Model: MET-P2	Date: 21-Oct-16	No.: RM0AL004a
---------------	-----------------	----------------

Subject: Firmware Release Note: NetworkDocBox		Prepared by: Y. Ino	
From: 1st Tech Service Sect., MFP/Printer Tech Service Dept.			
Classification:	<input type="checkbox"/> Troubleshooting	<input type="checkbox"/> Part information	<input type="checkbox"/> Action required
	<input type="checkbox"/> Mechanical	<input type="checkbox"/> Electrical	<input type="checkbox"/> Service manual revision
	<input type="checkbox"/> Paper path	<input type="checkbox"/> Transmit/receive	<input type="checkbox"/> Retrofit information
	<input type="checkbox"/> Product Safety	<input checked="" type="checkbox"/> Other (Firmware)	<input checked="" type="checkbox"/> Tier 2

This RTB has been issued to announce the firmware release information for the **NetworkDocBox**.

How to change the color profile to that of a 2009 Spring or earlier model

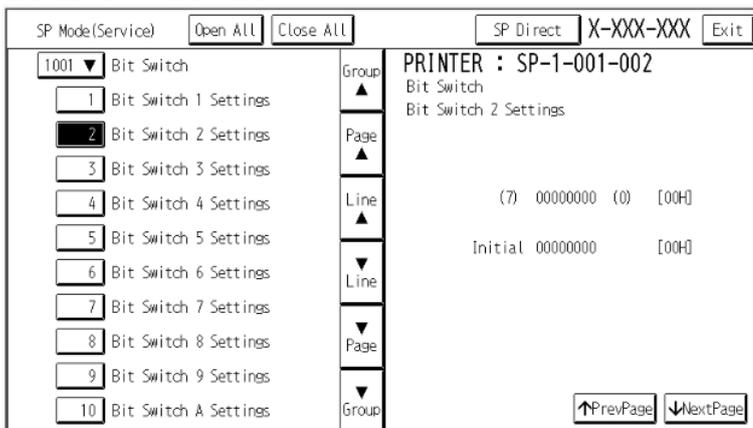
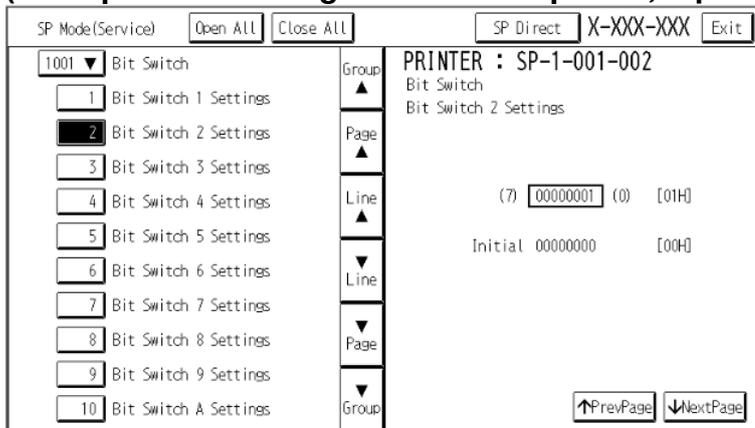
- Go to SP1-001-002.**

- Input '0' and '#'.
(If the profile is changed to a Xerox profile, input '6' and '#' in SP1-001-001.)**

- Exit the SP mode.**
- Turn the machine power OFF and then ON, to apply the change.**

Top Page > Main Chapters > Installation > Internal Multi-fold Unit FD3000 (M482-17, -21) > Installation Procedure

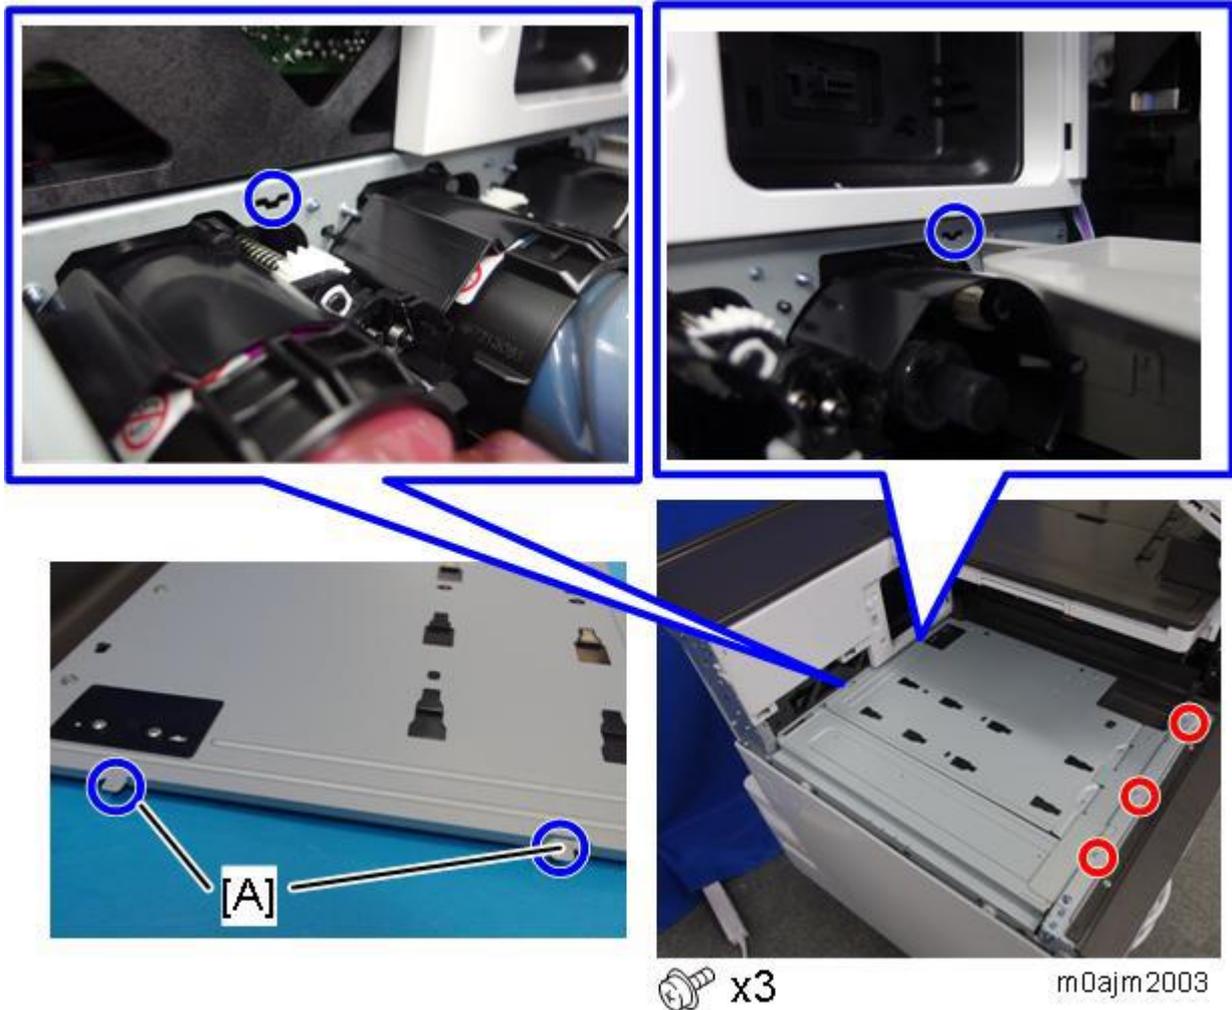
16. Attach the base plate. Before you attach the screws, insert the base plate's 2 tabs [A] into the slots in the machine. **The three screws circled in red below correspond to No.7 Bind Screw M3x6 of the Accessory Check list.**

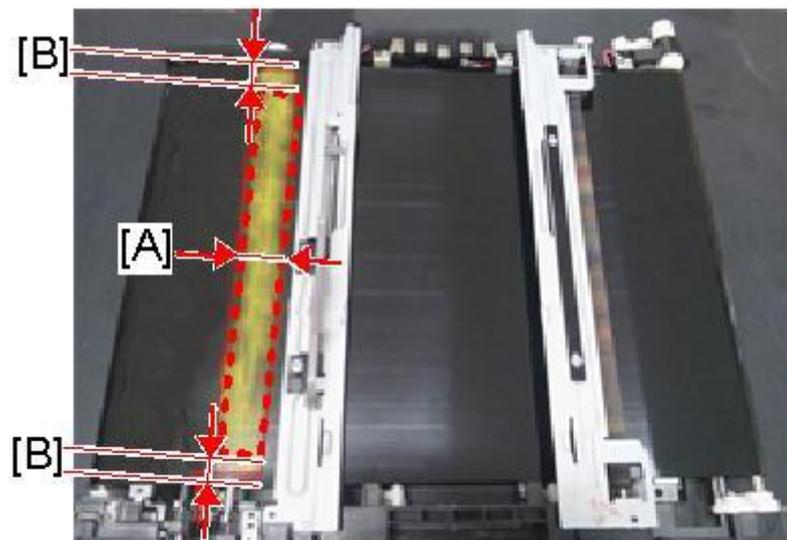
~~7 Attach the image transfer cleaning unit.~~

7 Put toner on the image transfer belt.

[A]: 20mm or more

Figure1 right rear cover

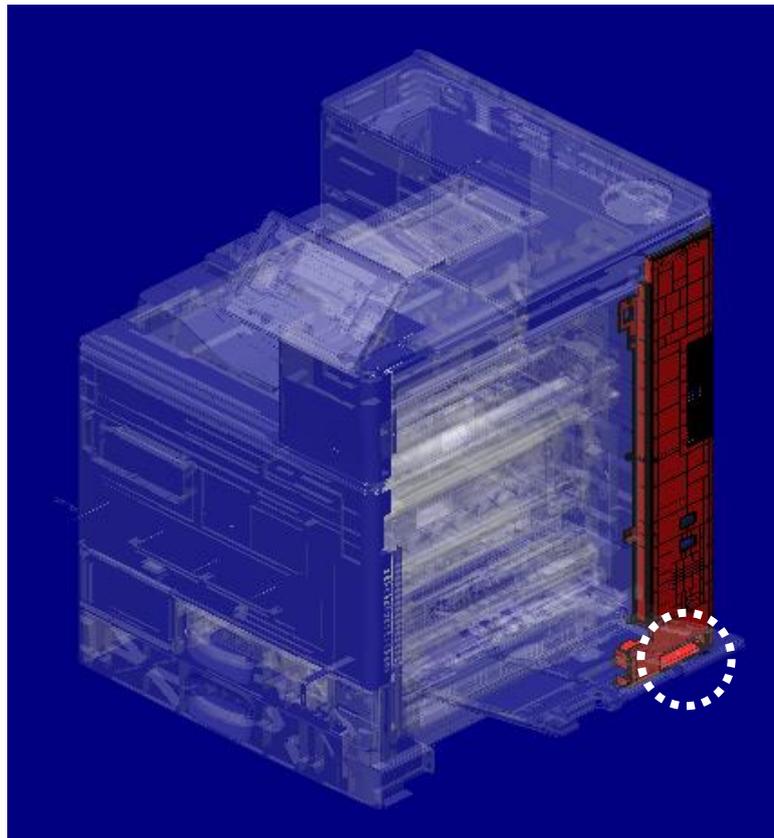
- Make sure to do the following when installing the machine:
Hold the grip of the right rear cover as shown in **Fig. 2 (CORRECT)**.
Insert your fingers **all the way up and inside the grip**.
- If you do not, the right cover will break, as shown in Fig. 4.

INCORRECT paper transport between FD3000 and SR3210/3220

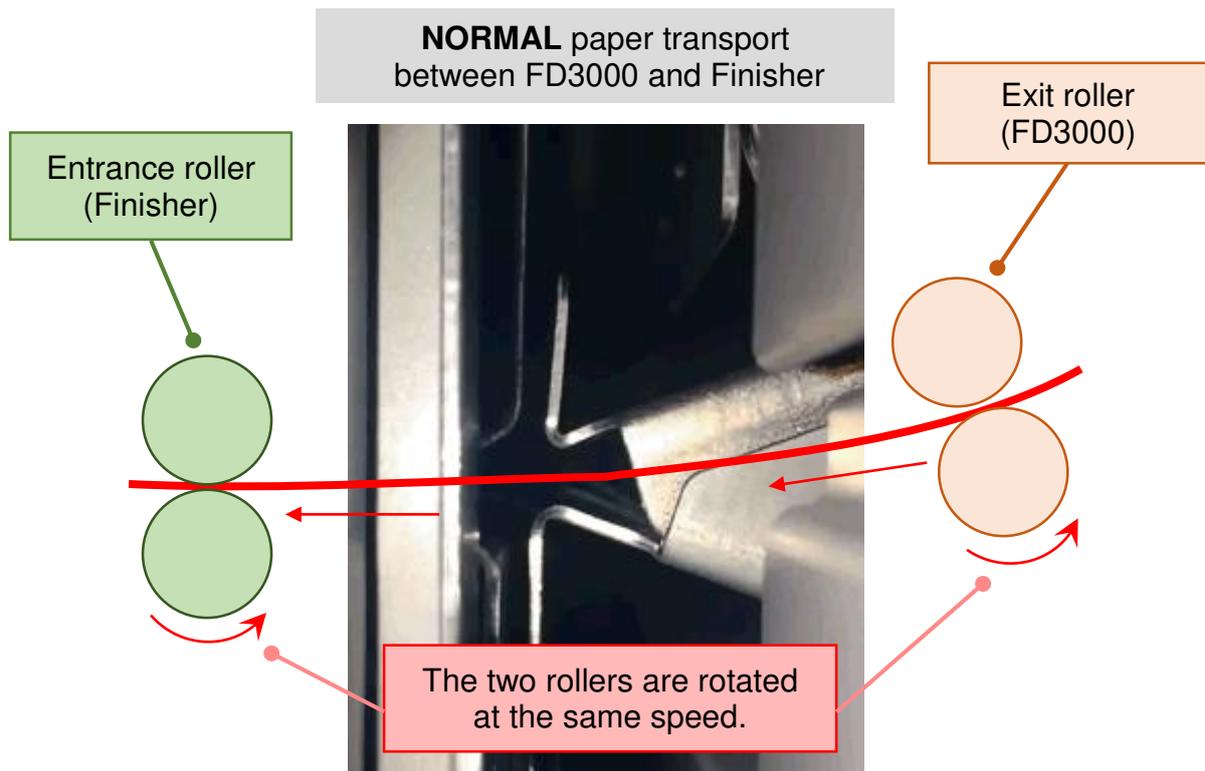
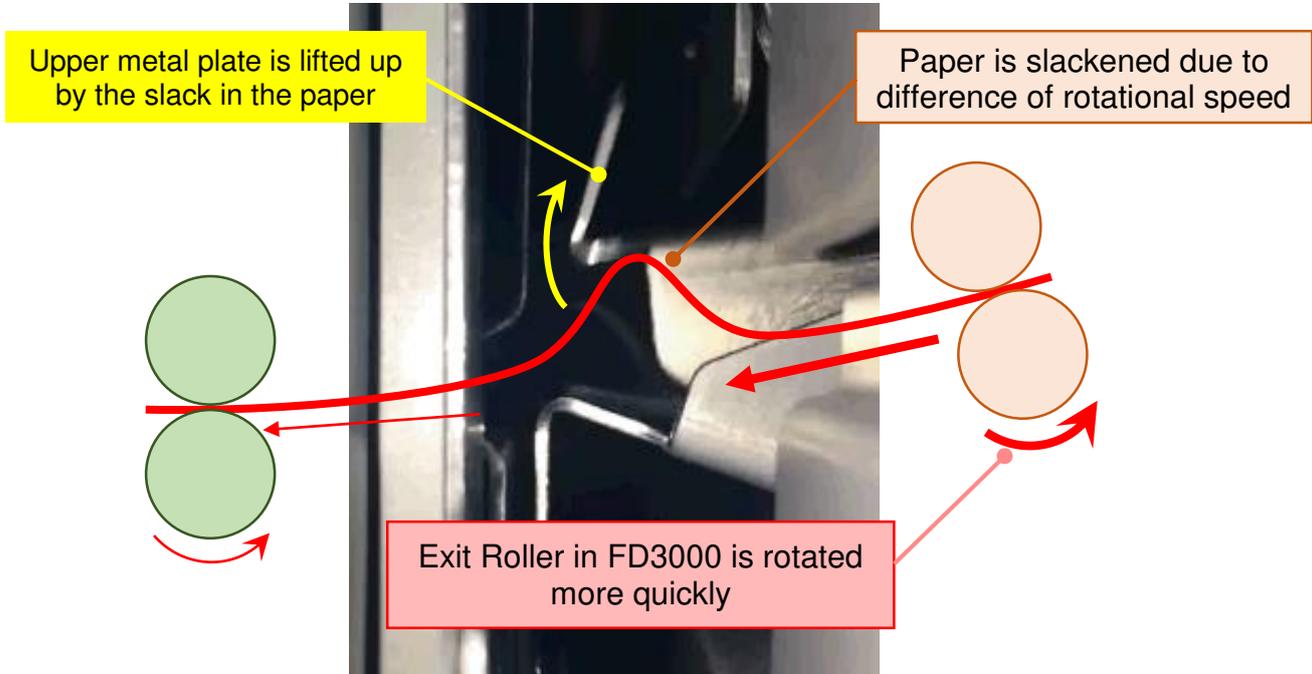
Due to the above error, the exit roller in the FD3000 is rotated at a higher speed than the entrance roller in the finisher (Normally, these speeds should be the same). This causes slack to develop in the paper, which then lifts up the upper metallic plate. As a result, the upper plate then drops onto the lower plate. Then a metallic “clinking” noise is produced.

The firmware was modified to correct the roller speed control.

Overview

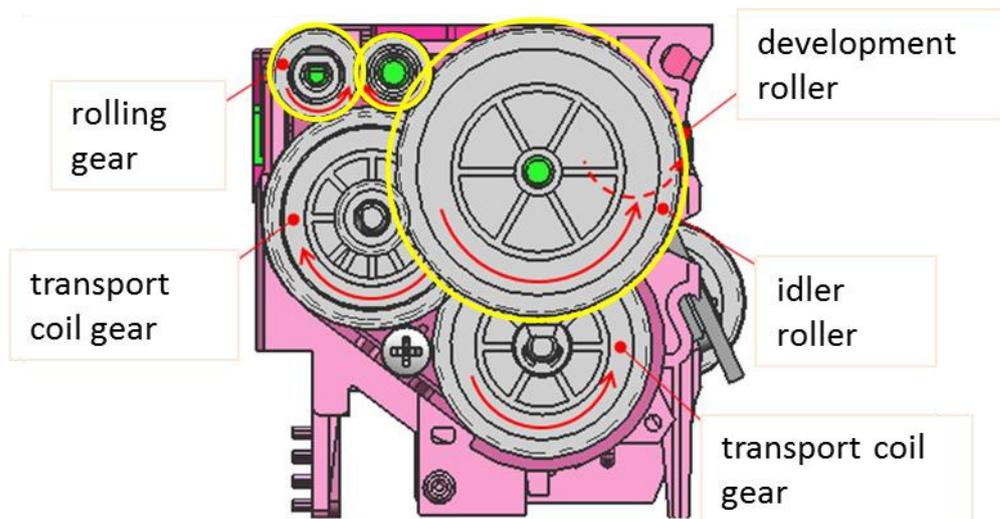
Three new gears (yellow circles) are added. They are driven from the developer collection coil gear, so the seal is automatically wound. This mechanism works at installation and/or replacement.

Before the modification, PCDU covers were included separately in the machine's carton box.

After the modification, the PCDU covers are already attached to the machine.

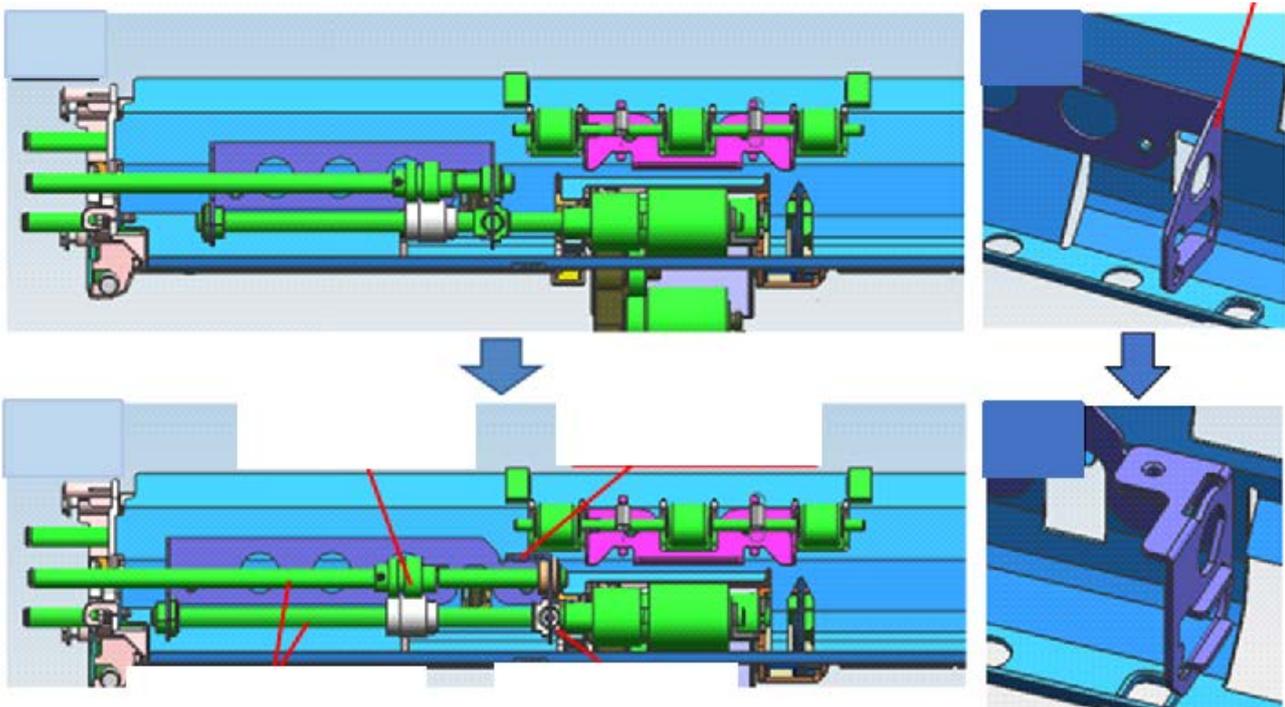
Change 3: The shape of the brackets and bearings, length of the roller shaft, and the gear position has changed. Also e-rings added.

Old P/N <Group B>	New P/N	Description	Int	Q'ty	Note
08050104	08050104	RETAINING RINGS-E:SILENCER:DIA4	-	2->3	C
D1494770	D0BQ2608	SHAFT:SEPARATOR:DRIVEN:ASS'Y	X/X	1	C
M0BW2615	D0BQ2615	GUIDE PLATE:SEPARATOR:ASS'Y	X/X	1	C
D1492619	D0BQ2619	SHAFT:SEPARATOR:DRIVE:ASS'Y	X/X	1	C
D2412653	D0BQ2653	COIL SPRING:PRESSURE:SEPARATOR	X/X	1	C

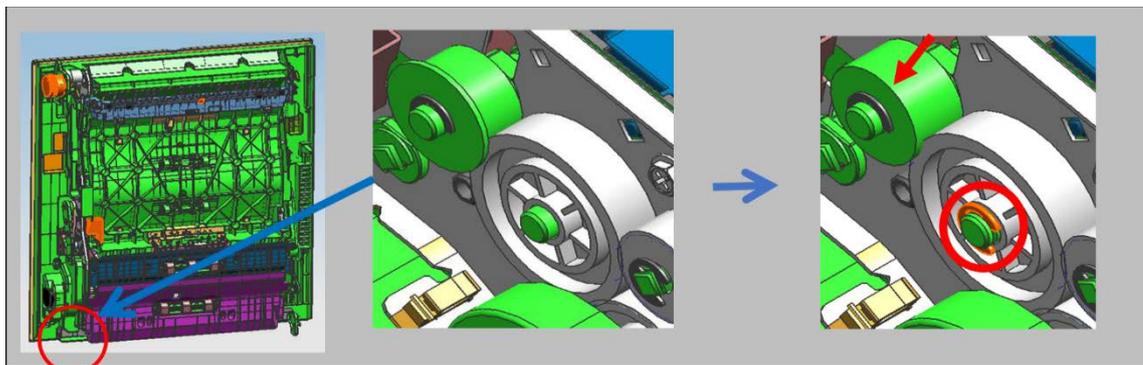
Change 4: There are no protruding parts to hold the gear. An e-ring added to stop the gear in position, and a groove added to the shaft for the e-ring.

Old P/N <Group B>	New P/N	Description	Int	Q'ty	Note
07200040E	07200040E	RETAINING RING - M4	-	3->4	D
D2414631	D0BQ4631	SIDE PLATE:REAR:DUPLX:PEEN	X/X	1	D
D2414644	D0BQ4644	GEAR:MECHANICAL ROLLER CLUTCH	X/X	1	D

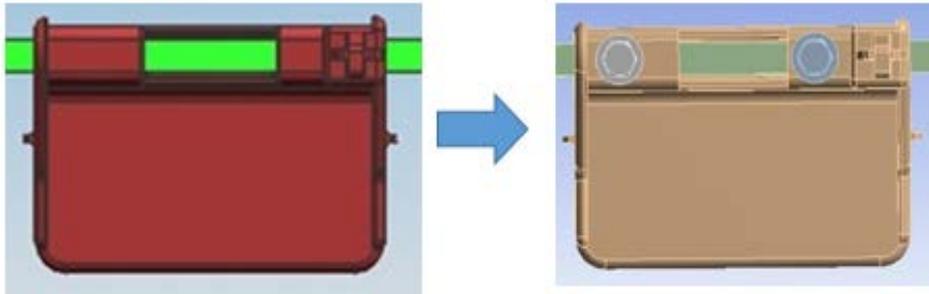
Change 5: The grip of duplex unit has been changed from press fit to screw type.

Old P/N <Group A/B/D>	New P/N	Description	Int	Q'ty	Note
-	03603006N	SCREW - M3X6	-	0->2	E
D1754654	D0BQ4654	SHAFT:LEVER:LOCK	X/X	1	E
D1494655	D2894655	GRIP:DUPLEX UNIT	X/X	1	E
